HOWARD COUNTY HISTORIC PRESERVATION COMMISSION

April Agenda

Thursday, April 6, 2017; 7:00 p.m.

This Agenda identifies the work proposed and includes comments and recommendations from DPZ Staff. The recommendations included here do not constitute a decision of the Commission.

Figure 30 - Fireplace

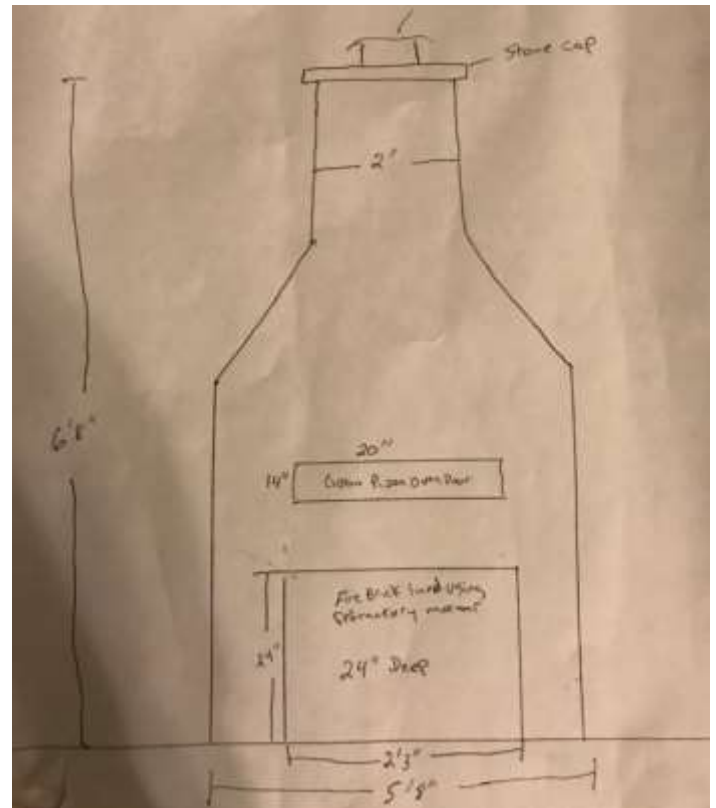
Staff Comments: Chapter 9.B of the Guidelines states that work that requires a Certificate of Approval includes, "removing live trees with a diameter of 12 inches or great 4.5 feet above ground level." The tree that was removed in February 2017 appears to meet these size requirements. The Applicant stated that the tree was diseased and cracked with the help of an arborist. Staff inquired if there was an arborist report available, but the Applicant stated there is not. The Applicant has provided additional photos, shown in Figures 24 and 25 that show possible disease

The stone that has been used and will continue to be used on the site is compatible with the historic granite house. This work complies with Chapter 9.D recommendations, “construct new site features using materials compatible with the setting and with nearby historic structures, particularly for features visible from a public way” and “construct new terraces or patios visible from a public way from brick, stone or concrete pavers design to look like indigenous stone.” The wrought iron railing complies with Chapter 9.D, which explains that “historic metal fences found in the historic district include wrought iron fences” and recommends, “install open fencing, generally not more than five feet high of wood or dark metal.” The overall dimensions of the patio and walkway were unclear so Staff took their own measurements of the patio, which will be provided to the Applicant and the Commission. Staff has no objection to the overall shape and concept of the patio, but the specific dimensions do need to be clearly understood.

Staff Recommendation: Staff recommends Approval of the new tree plantings. Staff recommends Approval of the side walkway, retaining wall and retroactive approval of the wrought iron railing. Staff recommends Approval of the hardscaping walkway and patio and chimney/fireplace drawing.

Figure 49 - Proposed sign

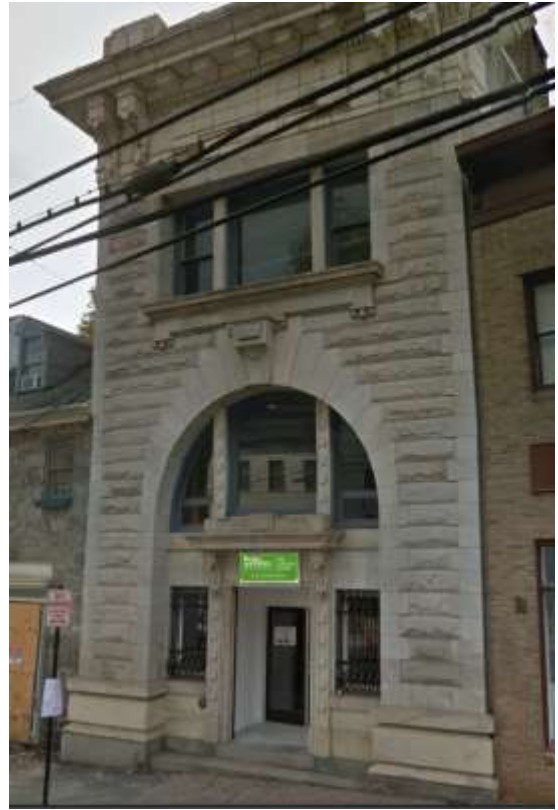
Staff Comments: The sign generally complies with Chapter 11.A (page 80) recommendations, “use simple, legible words and graphics” and “keep letters to a minimum and the message brief and to the

point.” The sign only identifies the name of the business franchise. The sign will have two colors, which complies with Chapter 11.A (page 80) recommendations, “use a minimum number of colors, generally no more than three. Coordinate sign colors with the colors used in the building façade.” The green background of the sign is very bright and does not match the architecture of the stone building. If there is another color option available that is more neutral, Staff recommends the Applicant amend the application.

The sign does not comply with Chapter 11.A (page 80) recommendations to use “historically appropriate materials such as wood or iron for signs and supporting hardware.” The sign will be made of aluminum, but will be flat mounted to the building so the lack of depth in the modern material will not be highly noticeable.

Chapter 11.B (page 83) of the Guidelines recommends, “Incorporate the sign into the façade of the building. Signs should fit within the lines and panels of the façade as defined by the building frame and architectural details.” This sign will be installed directly above the front door, within a panel detail above the door. Signs have been used in this location in the past and it is the most appropriate location on this building to install a sign. This sign, unlike the previously installed, is correctly shown in the rendering as fitting within the panel detail and showing a stone border around the sign.

Staff Recommendation: Staff recommends Approval as submitted, but recommends a more neutral color be used if possible.

Figure 55 - Axonometric view of building

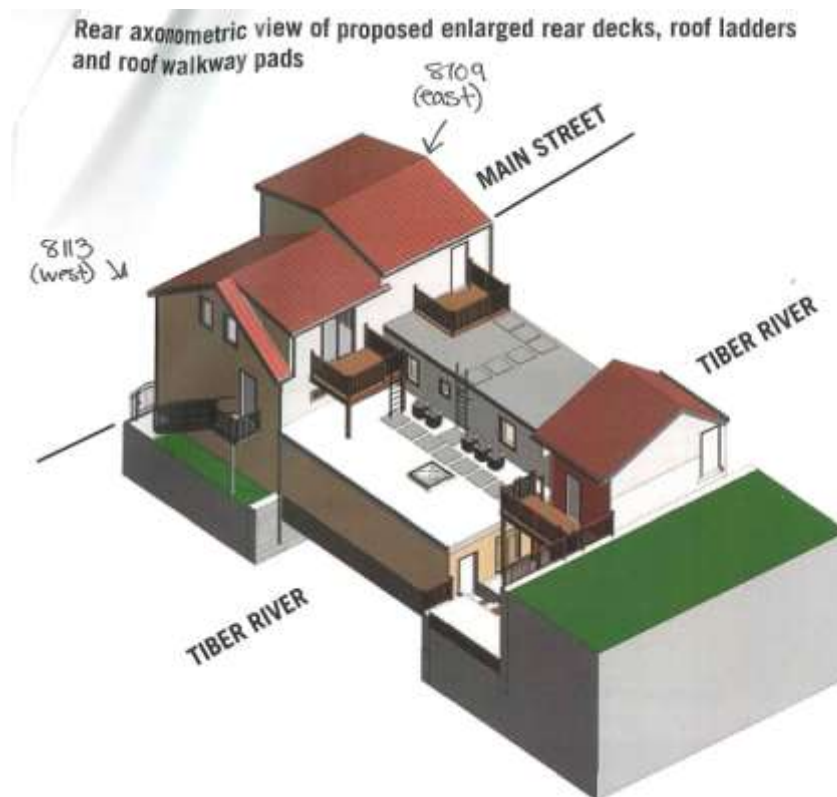
Staff Comments: The application complies with Chapter 6 recommendations for rehabilitation. This proposal generally consists of restoring the property to its pre-flood condition for the front façade and restoring/rebuilding the remainder of the building as needed. Alterations to the rear of the property will bring consistency to a mix of additions over the years and provide emergency egress for all tenants. This is a very complex project due to the extent of damage. While Staff has tried to encompass all repairs and alterations in the Staff report, the architectural drawings and other submission materials generally provide the entire scope of work, with the exception of small adjustments on details such as the rear decking materials.

The Applicant proposes to replace the damaged wood siding on the side of the building with fiber cement siding. This location will be difficult to reach for maintenance once the staircase is reinstalled and the gate is installed. Chapter 6.D states, “if wood siding must be replaced on a historic building, a composite siding material may be considered, if wood is not a viable option, the composite siding conveys the appearance of the historic material, and application of the substitute material does not damage or obscure historic features. The texture, width, shape, profile and finish of the substitute siding material should be similar to the wood siding it replaces.” The proposed fiber cement siding will only be used for the first floor on the side of the building and then the second floor is back to the existing wood siding. This entire side of the building needs to be structurally rebuilt and in this case the use of fiber cement complies with the Guidelines. The Applicant proposes to use the ‘traditional cedar’ grain fiber cement siding. Staff would like to see a side by side comparison of the existing wood siding to the proposed wood grain fiber cement to confirm this is the appropriate choice and that the texture of the new fiber cement will match the existing wood.

The removal of trees complies with Chapter 9.B recommendations, which recommend against the removal of live mature trees unless, “it is necessary due to disease or to prevent damage to historic structures.” The trees are growing adjacent to the historic retaining wall, which indicates the trees were not purposefully planted and are a threat to the building. Chapter 9.B recommends “plant new trees and shrubs far enough from buildings to avoid moisture problems and damage to the buildings from falling limbs and roots as the plants grow.” The existing trees do not follow this Guideline as the trees are not far enough from the historic wall.

- 6) Approval of all alterations to the rear of the building, including painting, expanded rear decks in either wood or black metal, walking pads, replacement of the roof, removal of trees, and fiber cement siding on the brick addition.
